UNITED STATES
NUCLEAR REGULATORY COMMISSION

SUBJECT: TECHNICAL REVIEW: HYDRAULIC PERFORMANCE AND EROSION
CONTROL OF THE PLANNED SALTSTONE DISPOSAL FACILITY
CLOSURE CAP AND ADJACENT AREA (DOCKET NO. PROJ0734)

Technical Review of the Hydraulic Performance and Erosion Control of the Planned Saltstone Disposal Facility Closure Cap and Adjacent Area

Figure 3: Plot of Historical Rainfall vs. Water Levels in the Z-Area Well ZBG 2 (Figure FFT-1.3 from SRR-CWDA-2016-00004)

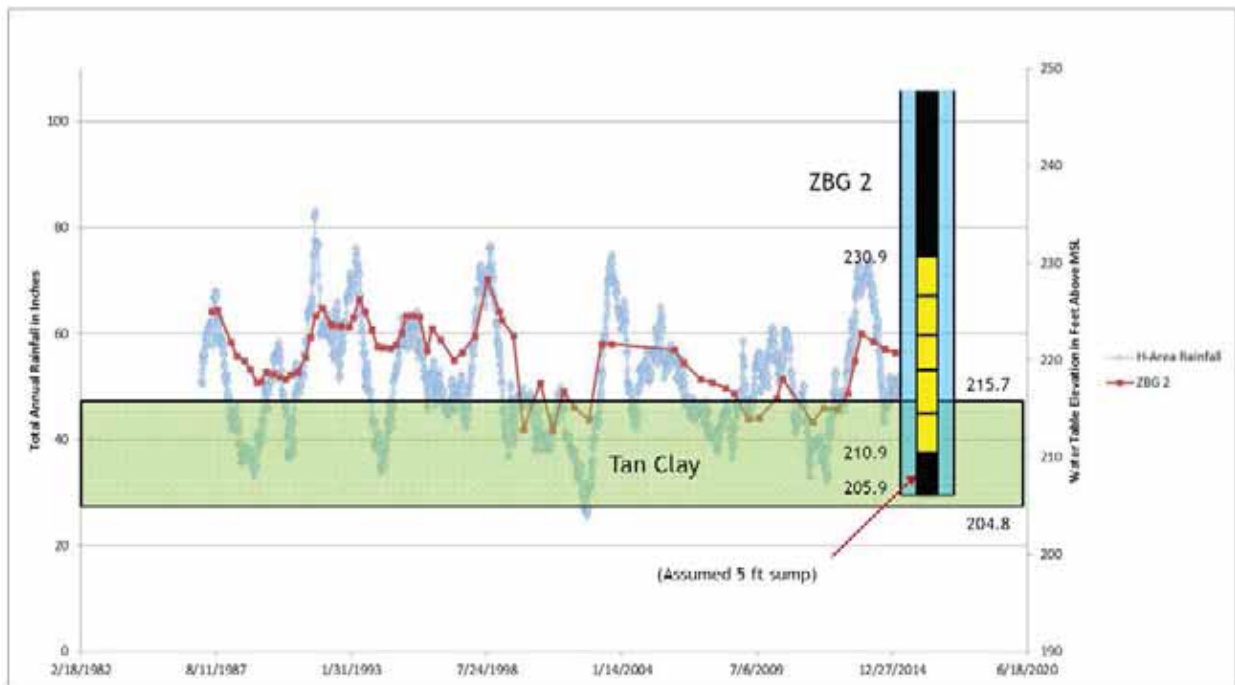
The NRC 2016 OOV report also discussed the DOE sensitivity analyses on precipitation and infiltration rates. The DOE ran multiple simulations with the HELP code using annual precipitation values ranging from a minimum of 29.8 in/yr [75.7 cm/yr] to a maximum of 68.6 in/yr [175 cm/yr]. Sensitivity analyses were described in the 2009 SDF PA and both the FY13 and FY14 Special Analysis Documents using the maximum infiltration value derived from that maximum precipitation value. However, Figure FFT-1.3 from SRR-CWDA-2016-00004

(see Figure 3 below) shows that the maximum precipitation value or the precipitation data set range that is used in the HELP model may need to be reevaluated. Figure 3 below also shows the plot of water levels in Well ZBG 2 in the Z Area versus historical rainfall. It is a comparison of water level readings over time for Well ZBG 2 to the moving one-year average rainfall for the nearest rainfall monitoring station in H Area. The moving one-year average rainfall for the H Area, located less than a mile south of the Z Area, shows averages that lie above the maximum annual precipitation value of 68.6 in used in the HELP model (WSRC-STI-2008-00244, Table 9). In addition, the moving one-year average rainfall for the H Area also lie above the 1964 annual precipitation of 73.06 in [185.6 cm] measured at the combined Savannah River National Laboratory/Central Climatology Site weather stations (WSRC-STI-2008-00244, Table 6) and the 1964 annual precipitation of 71.74 in [182.2 cm] measured at the 200-F weather station (WSRC-STI-2008-00244, Table 7). During the 2016 OOV, the NRC and DOE discussed additional information that might be included in the next revision of the SDF PA. Those possible revisions included updates to the meteorological data used to calculate expected ranges for infiltration in the near future that reflect uncertainty in the current dataset from the last 50 years and also infiltration projections that reflect the uncertainty in future climate states.

Figure 4: Conceptual Illustration of a Cross-Section from the SDF Engineered Cover Design (Figure 6 [Section B-B' from Sheet 1] in WSRC-STI-2008-00244)

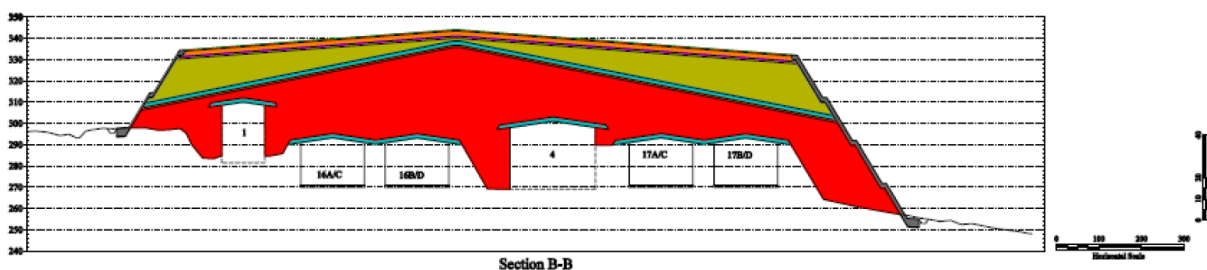
Although the FY14 Special Analysis Document stated that the conceptual design of the closure cap remains unchanged, due to the increased size of the newer 375-ft diameter disposal structures, some type of change to the conceptual design of the closure cap may be necessary

to account for the additional height (i.e., 43 ft (13 m) versus 23.5 ft (7.2 m) maximum internal height) unless the bases of the 375-ft disposal structures are lower in elevation than shown in Figures 6 and 7 in WSRC-STI-2008-00244. The increase in internal height of the 365-ft disposal structures represents an increase of approximately 20 ft (6.1 m), which may require some aspect of the closure cap design to change if any 375-ft disposal structure is to be located close to the perimeter of the closure cap. For example, SDS 7 or SDS 11 will be relatively close to the outer edge of the closure cap based on designs seen in Figure 4. Even if SDS 7 is built at 265 ft (81 m) above mean sea level, the thickness of the lower backfill will likely need to be increased if the slope of the upper lateral drainage layer is to be maintained, and therefore, the height of the side slope would need to be increased. If the conceptual closure cap design is to stay as close to the original design as possible, and if the minimum surface thickness of 10 ft [3.0 m] of non-waste material above the waste material and a minimum thickness of 1 ft [0.3 m] of middle backfill and 1 ft [0.3 m] of lower backfill are to remain, the engineered cover may be higher than previously modeled. If the cover is higher than previously modeled, the side slopes will be higher in elevation and an additional bench may be required. The other alternatives to avoid higher side slopes would be to increase the slope of the upper lateral drainage layer or to increase size or area of the closure cap; the longer the slope, the lower the top part of the side slope will be. Alternatively, the thicknesses of the individual layers could be changed. For example, currently the HELP model and the PORFLOW model have a lower backfill minimum thickness of 72 in [180 cm] over the roofs of the disposal structures. So that the engineered cover does not become too big or too high, a future design could include a thinner minimum lower backfill layer over the cells. However, unless the base of the disposal structures are constructed at sufficiently deeper elevations, all alternatives involve changing the design in some way with the consequence that a majority of infiltration and erosion calculation results as documented in

WSRC-STI-2008-00244 would need to be reassessed and most likely reanalyzed and recalculated. It is possible that the southern part of the closure cap (right side of Figure 5) may not need such recalculations if tall disposal structures such as SDU 10, 11, and 12 as identified in Figure 5 are not built.

Figure 5: Layout of Disposal Structures (Figure 3.2-2 in the FY14 Special Analysis Document)

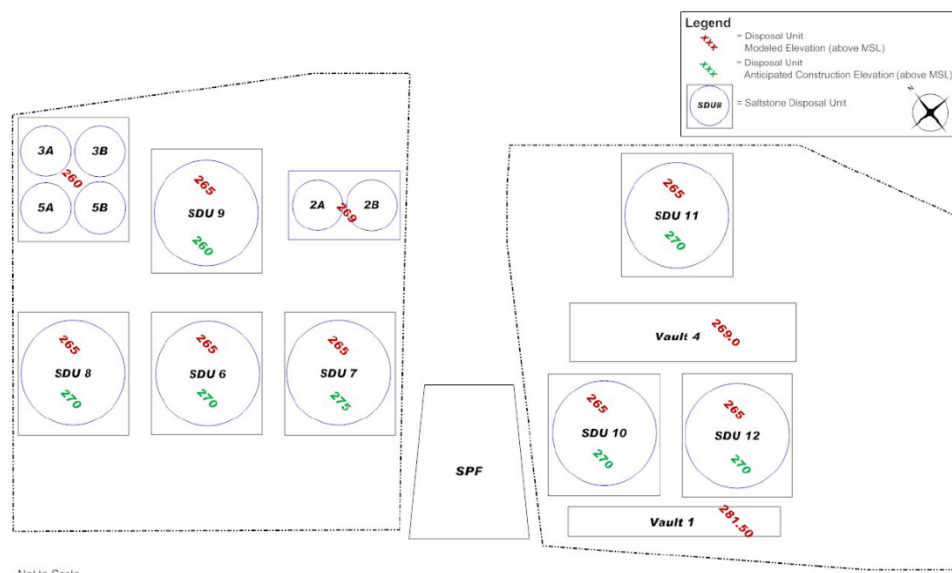
A taller or larger closure cap would require more material, most likely material that makes up the middle and/or lower backfill. Currently the maximum designed thickness of the middle backfill layer is 20.6 ft [6.28 m], while the maximum design thickness of the lower backfill layer is envisioned to be nearly twice as thick (see Figure 4). If the borrow material that makes up most of the backfills requires some modifications to meet design specification (e.g., sand or clay to increase or decrease the hydraulic conductivity, respectively), then the NRC staff would consider this an important technical modification to the design and would need to evaluate the impact of the size, quality, and location of the source of the borrow area or areas.
